Addendum #1

RE: **IFB #030-0-2022GS – Warwick Health Services Academy – Renovations**

ADDENDUM NO. # 1

PROJECT # 21710.25

ITEM NO. A1 SHEET A1.2 – FINISH & DOOR SCHEDULE

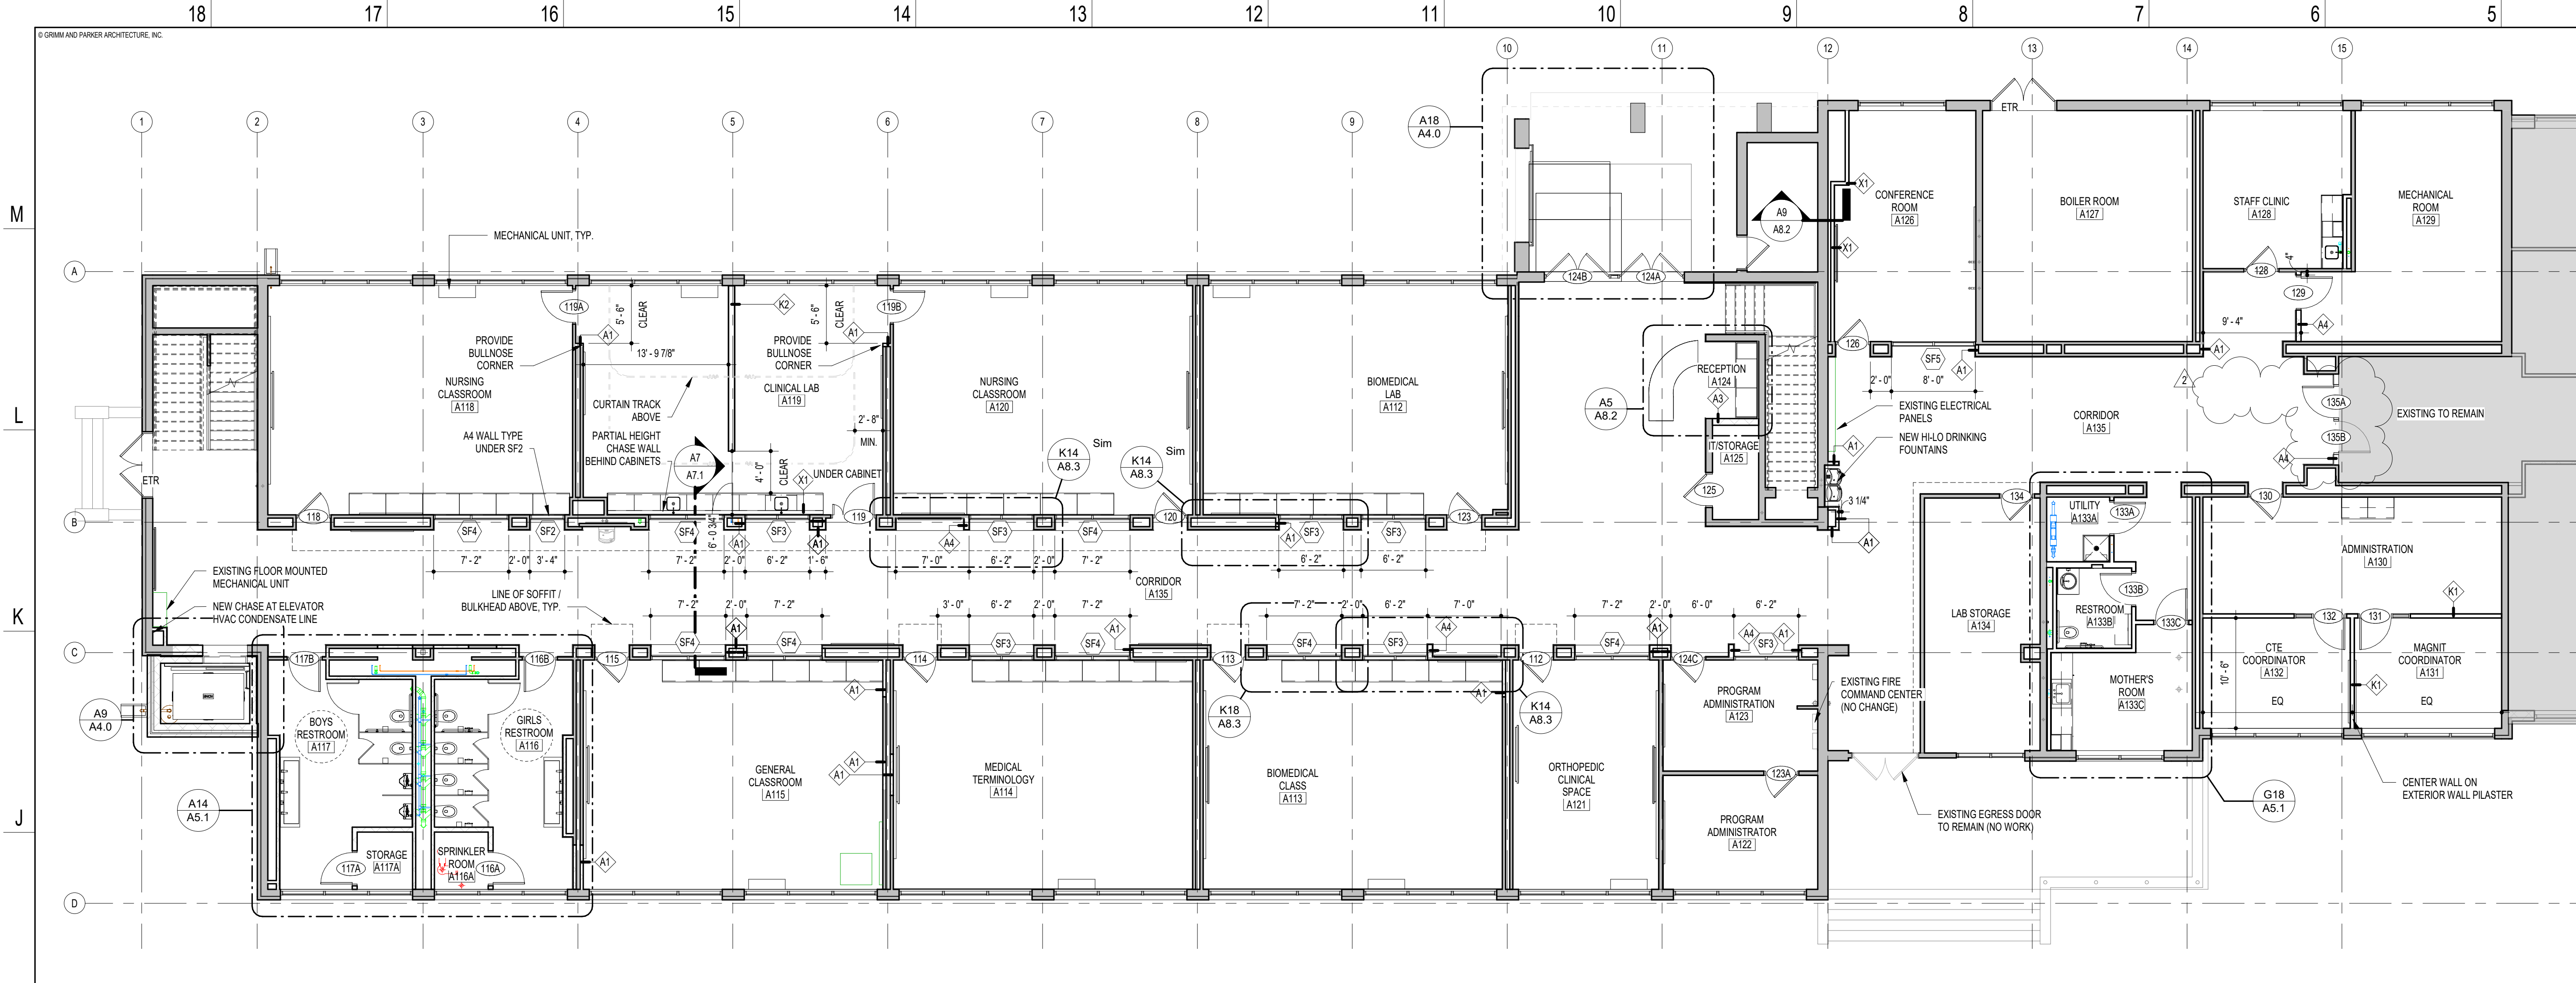
Revise sheet A3.1 per attached reissued sheet:

REVISED REMOVED “SEE ALTERNATE #2” FROM DOORS A134/A135 AS THESE DOORS ARE
EXISTING TO REMAIN.

ITEM NO. A2 SHEET A3.1 – FINISH & DOOR SCHEDULE

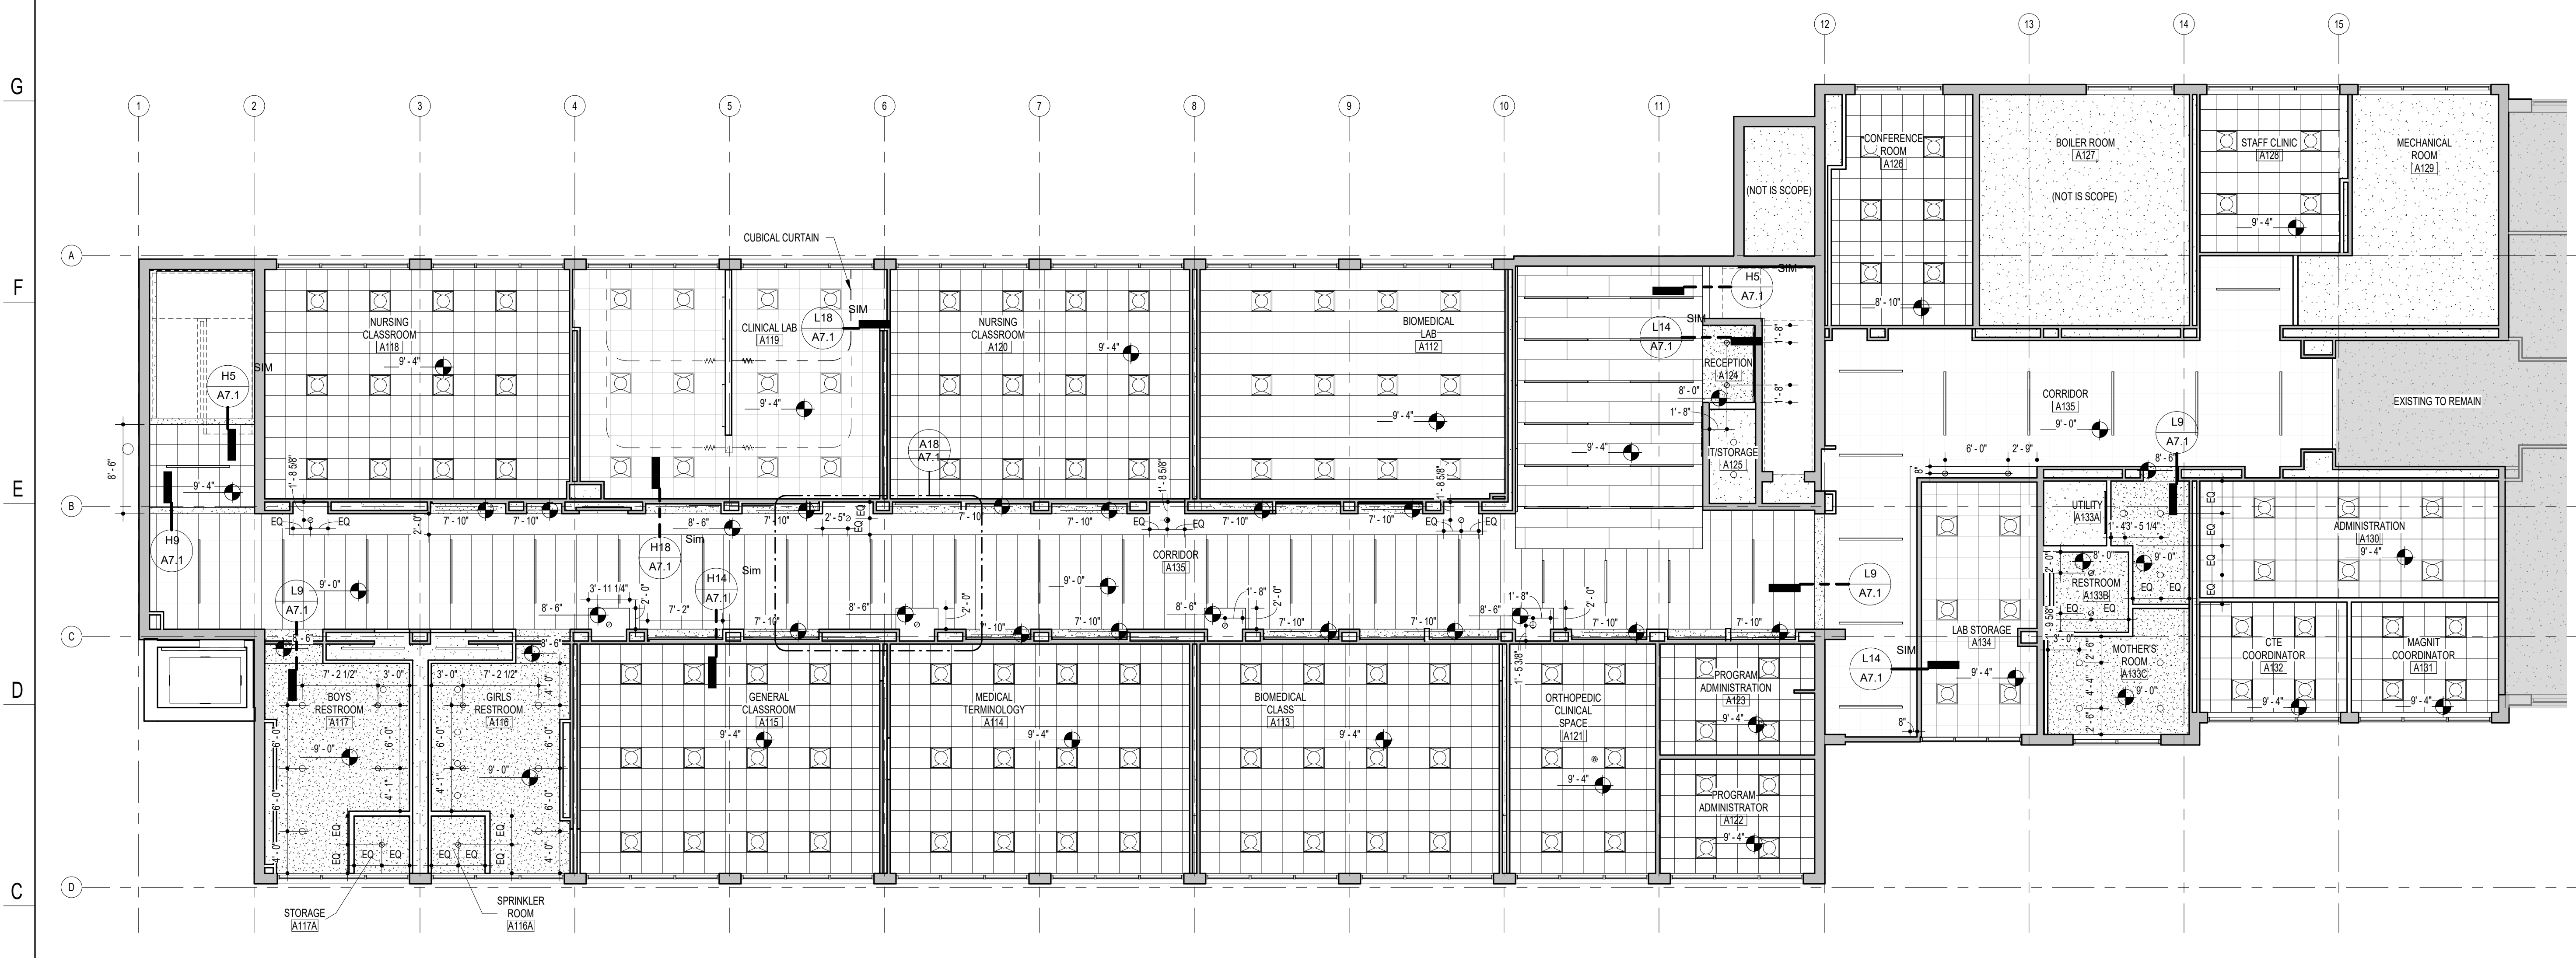
Revise sheet A3.1 per attached reissued sheet:

REVISED DOOR SCHEDULE.

REVISED DOOR NOTES.
